Access Compliance Report

Public Rights-of-Way

(Pedestrian Signals)

Intersection ID: N/A	Main Street:	Cross Street: N/A	Location: N/A
ADA ID: 515C2C39DBCA	Signal Type: One Push Button-Non APS	Overall Compliance: No	Severity Score: BTN 1: N/A BTN 2: N/A No BTN: N/A
Codes/Mitigation Info/Possible Solution		Field Measurements/Component Compliance

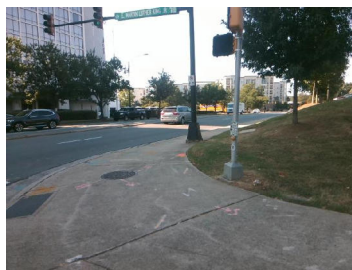
PROW/ADA: TMUTCD 4e.08, R406.2, R404.7.3, R104.2, R209.1

Yes	B 1 Pressure (#)	0.5	N/A	B 2 Pressure (#)	N/A
No	B 1 Closed Fist Operation?	No	N/A	B 2 Closed Fist Operation?	N/A

Yes	B 1 Clear Xing Direction?	ClearlyMarked	N/A	B 2 Clear Xing Direction?	N/A
	B 1 Crossing Direction	To NE		B 2 Crossing Direction	N/A
Yes	B 1 DistanceTo XWalk (in)	60.0	N/A	B 2 DistanceTo XWalk (in)	N/A
No	B 1 DistanceTo Curb (in)	187.0	N/A	B 2 DistanceTo Curb (in)	N/A
Yes	B 1 Diameter (in)	2.0	N/A	B 2 Diameter (in)	N/A

Possible Solutions: Replace Signal Push Button With APS Button on New Post. Remove & Relocate Sign.
